**SDCI #3025113**

**4215 S. Trenton St.**

**FULL DESIGN REVIEW / DESIGN RECOMMENDATION**

# Link Townhomes / West

## DESIGN CONCEPT, ARCHITECTURAL CHARACTER + MASSING (1A1 + 1B)

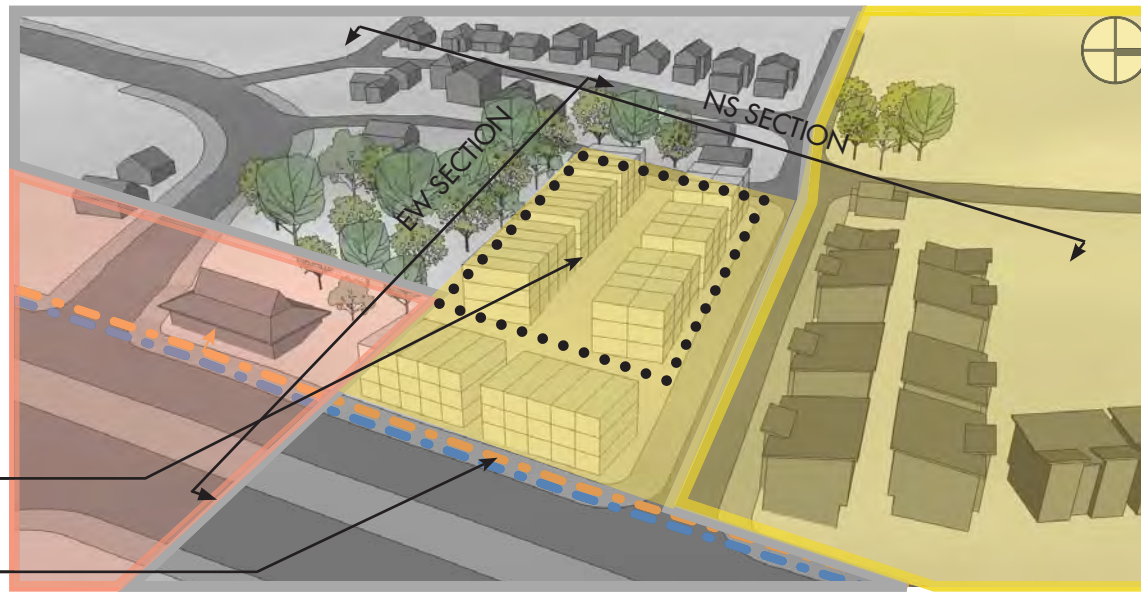
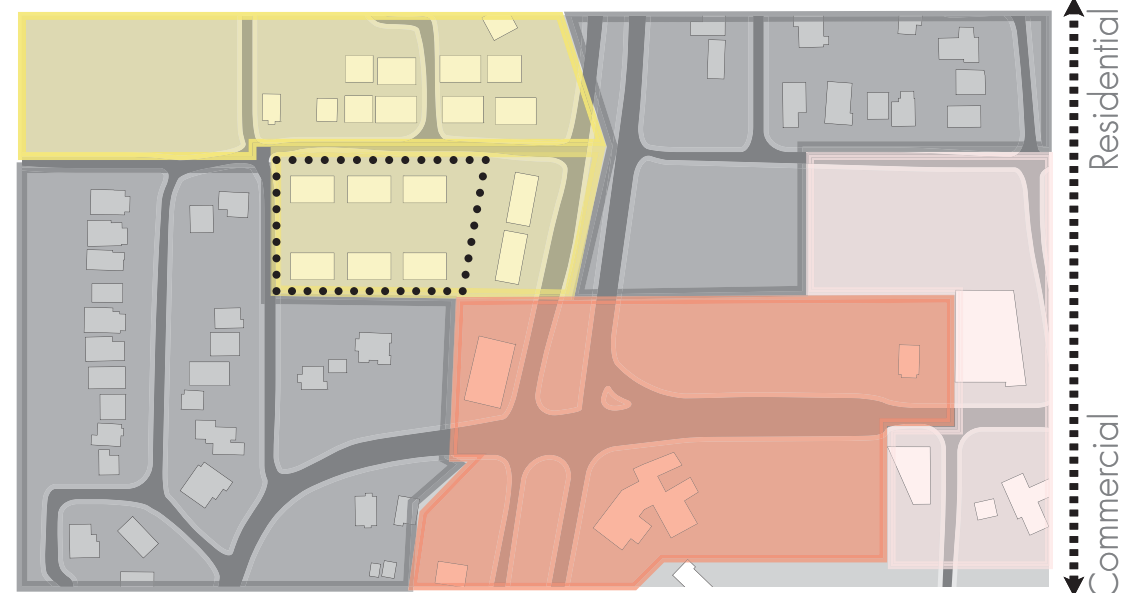
Same roof form and number of levels did not differentiate the different townhome buildings

Townhomes in EDG preferred option did not active the commercial edge of the site

Individually stepped gabled roofs of the southern townhome buildings are a more traditional roof form better transitioning to single-family homes.

Townhomes along Trenton continue the commercial nature of the live-work bldgs, but the reduced number of floors better matches the proportion of the townhomes across the street

## DESIGN CONCEPT, ARCHITECTURAL CHARACTER + MASSING AND VEHICULAR/BICYCLE PARKING AND ACCESS (1AII + 4A)

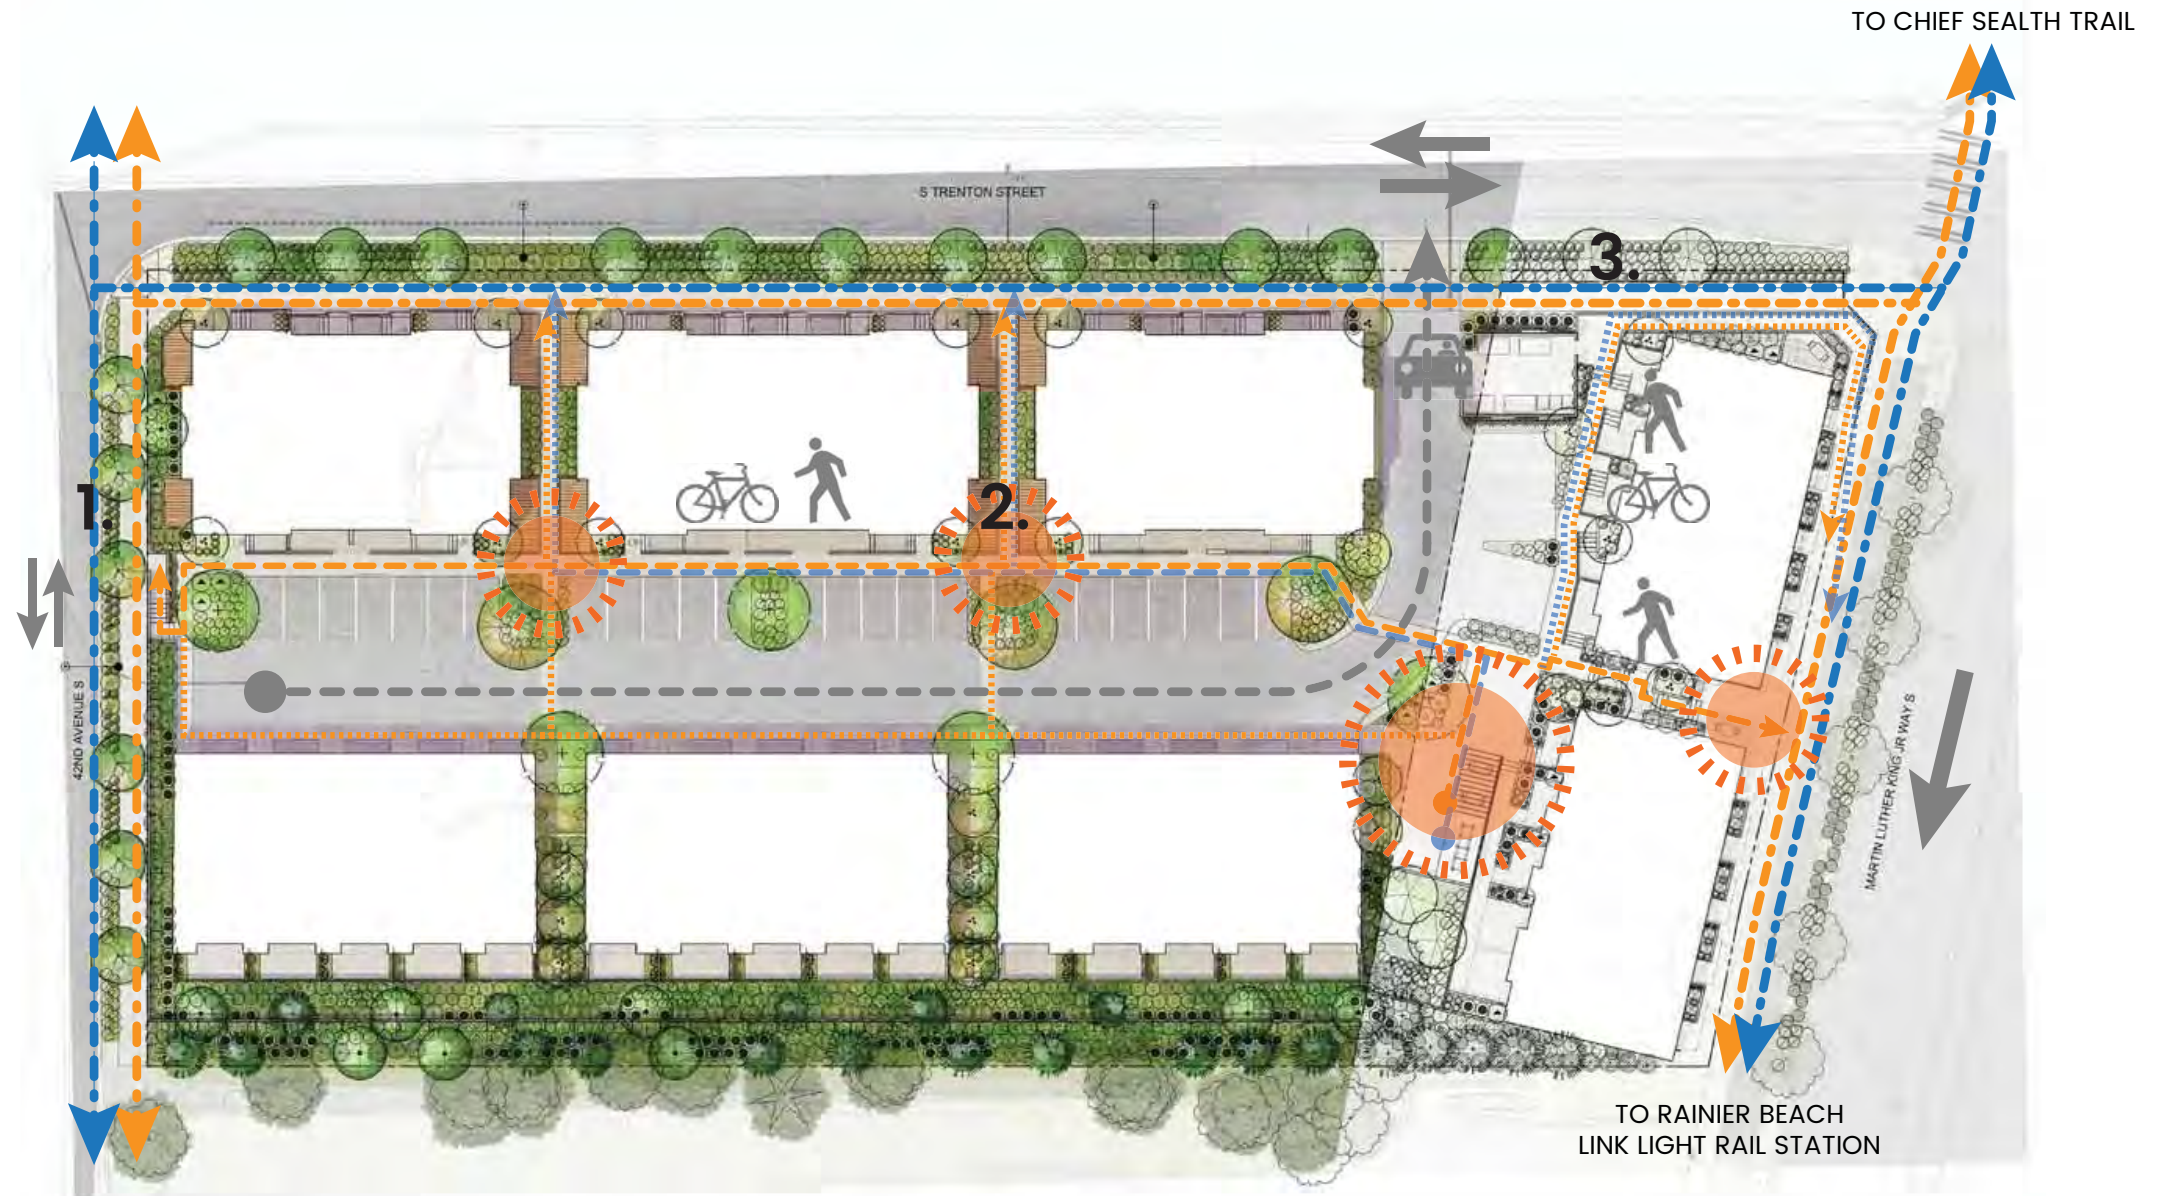
The Board encouraged a development that has more opportunities for communal gathering spaces and amenities onsite and requested that this concern be strengthened in the next design iteration.

The Board voiced concern the site circulation is primarily vehicular focused and emphasized connective opportunities for pedestrian and cyclists is important. They stated it was an aspect of the design needing to be strengthened.

To strengthen the site connections an access point was added between the site and the adjacent street. The ambiguous pathway between the North and South units was better defined with clear crosswalks delineated by a change in material. These pathways further reinforce the intersections along the primary E-W route through the site increasing the frequency of neighbors passing one another. The pedestrian walkway adjacent to the driveway was eliminated to clearly separate the different modes of transportation.

A stair was added to provide a pedestrian connection from the site to 42nd Ave S.

Connections from the principle E-W route to Buildings D-F have been delineated with crosswalks across the driveway. These additional pathways further reinforce this intersection of pathways where neighbors may meet.

The site plan at the EDG meeting showed a walkway adjacent to the driveway. This has been eliminated to further separate the vehicular traffic from the bicycle and pedestrian traffic.

**NORTHWEST CORNER OF TRENTON + 42ND**

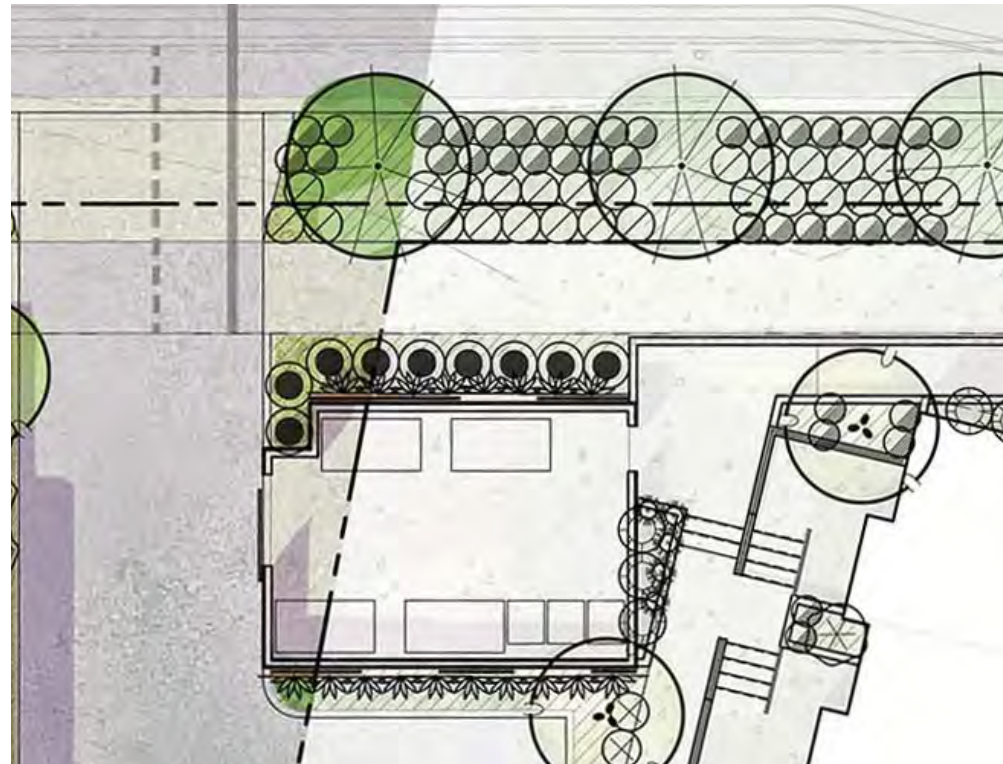
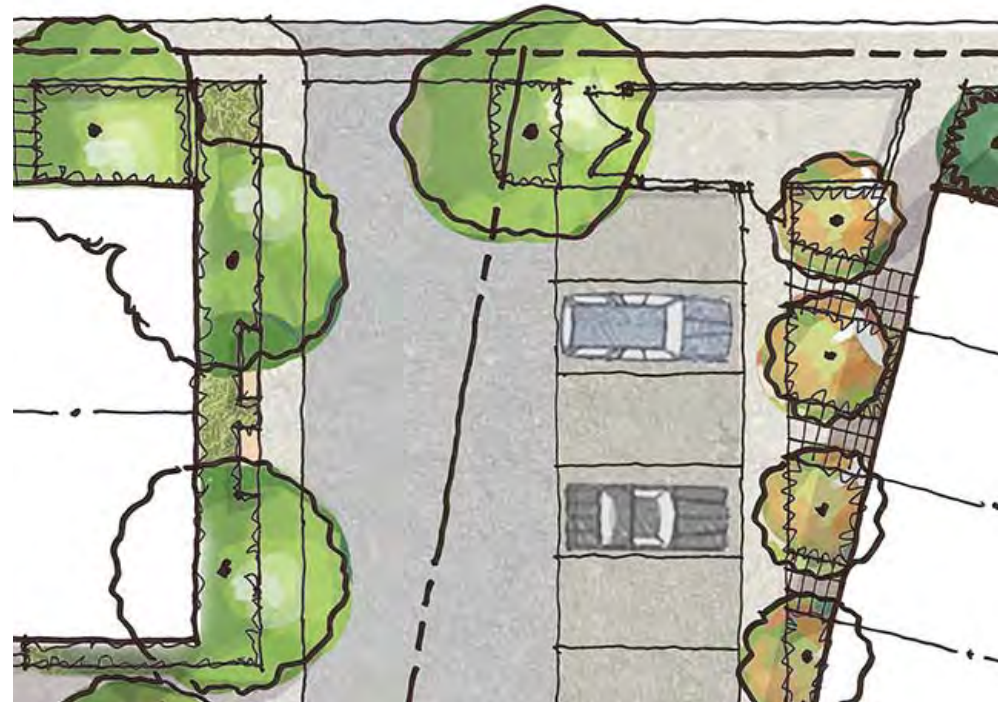
The Board stated that the residential development should create a positive connection to the 42nd Avenue South street edge. At the Recommendation meeting, the Board stated that they expect to see an ensemble of elements (lighting, fenestration, landscaping, entries, screening, hardscape, etc.) that addresses security, site connectivity and streetscape character appropriately.

A concrete stair with black powder-coated metal railing connects the project to the 42nd Street facade. Pole lighting at the stair will increase visibility and security in the evening hours and landscaping including vines at the mid-block stair wall increases visual interest and safety. Planting strips will border both sides of the sidewalk along 42nd and the elevation of the sidewalk, above the driveway, provides sightlines through the site towards MLK. The corner building includes a north + west facing deck, activating the corner of 42nd + Trenton. The building design up 42nd, from north to south, follows the transition of the neighborhood from dense multi-family projects to quieter single-family development.
